有關環境保護署對 A/YL-KTN/1016 的查詢

有關對運輸署 A/YL-KTN/1016 的查詢

Proposed Temporary Animal Boarding
Establishment with Ancillary Facilities
For a Period of 5 Years and Filling of Land

A/YL-KTN/1016 的擬議渠務建議詳細

Proposed Layout Plan

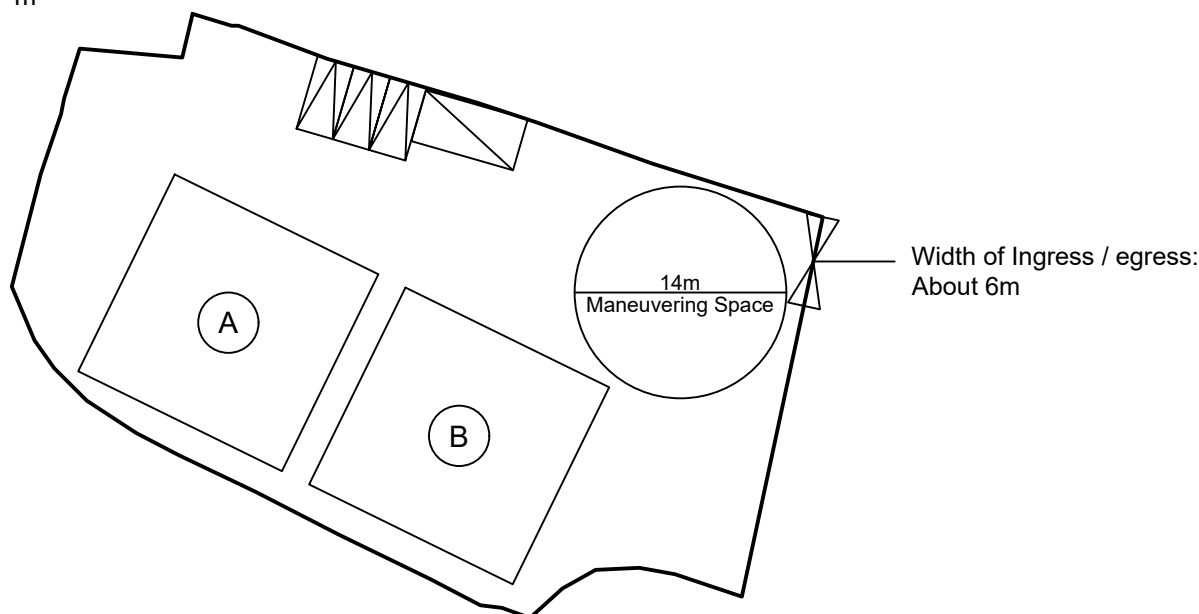
為了方便上落物料及寵物和方便員工駕車到本申請地點，現申請 1 個客貨車上落貨位置及 3 個私家車停車位。本申請地點不會對公眾開放。因此上述的客貨車上落貨位置及私家車停車位已足夠此申請運作。

在申請地點內有一個直徑超過 14 米的圓形空間，足夠讓車輛進行調遣的動作，進入本申請地點的車輛不會在公用道路上讓車輛等候進入本申請地點，

停泊在公用道路及以倒後形式進出本申請地點。參考文件末端的 Appendix 2。

Proposed Drainage Plan

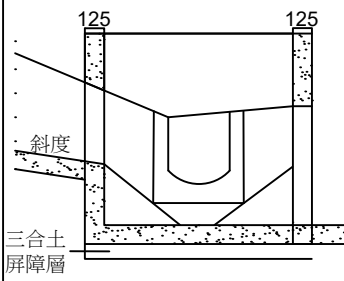
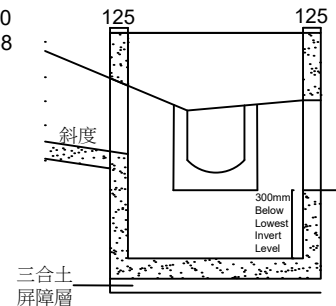
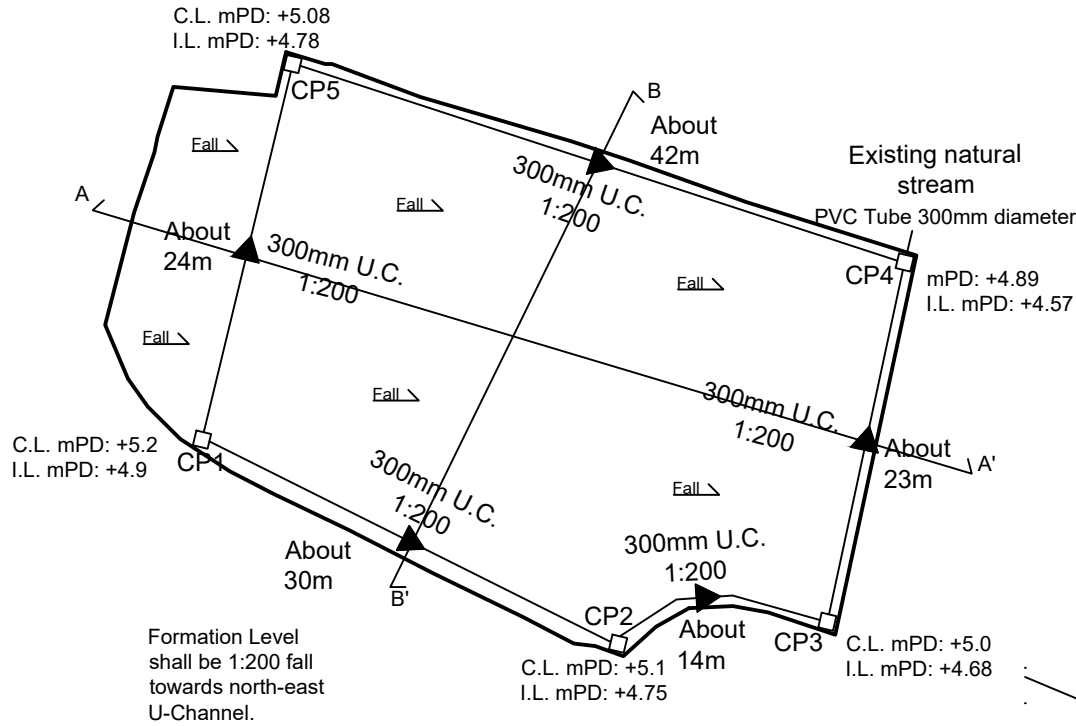
在申請地點的四周都比申請地點低，本申請範圍將會使用實心金屬板圍起，並會設有約 10cm 離地空間，確保無阻水流。

申請地點計劃鋪設 300mmUC 引導及收集雨水及地面水，根據 STORMWATER DRAINAGE MANUAL – Section 7.5.2 Rational Method 計算，現時的渠道有足夠的容量處理集水區內的水流量。

本申請會採用 300mmUC。

Figure 1 - Chart for the rapid design of U-shaped and half-round channels up to 600 mm

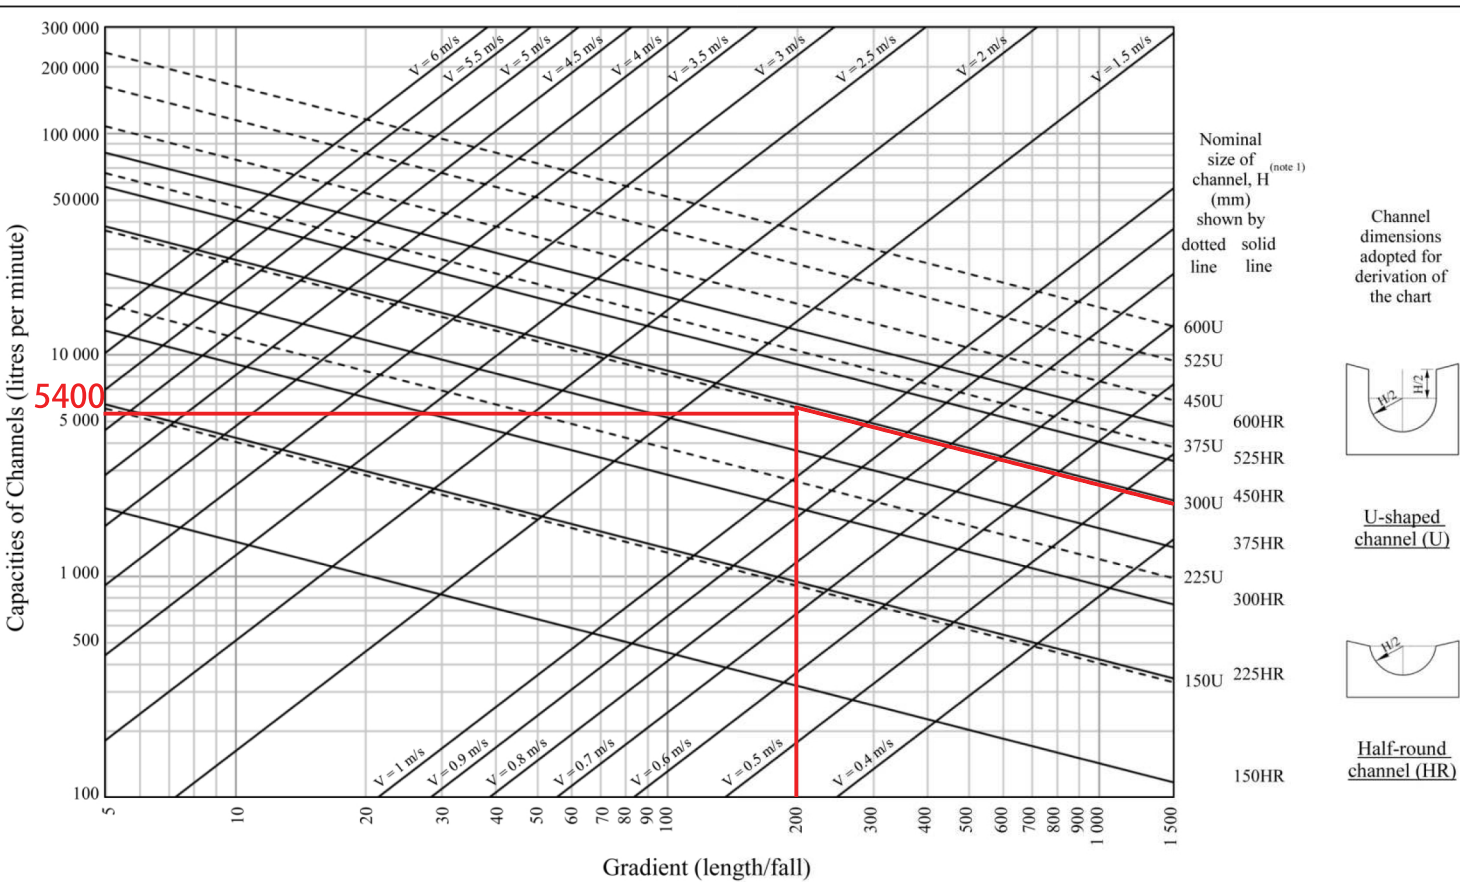
According to GEO Technical Guidance Note No. 43 (TGN 43),
For gradient 1:200, a 300UC will be suitable.
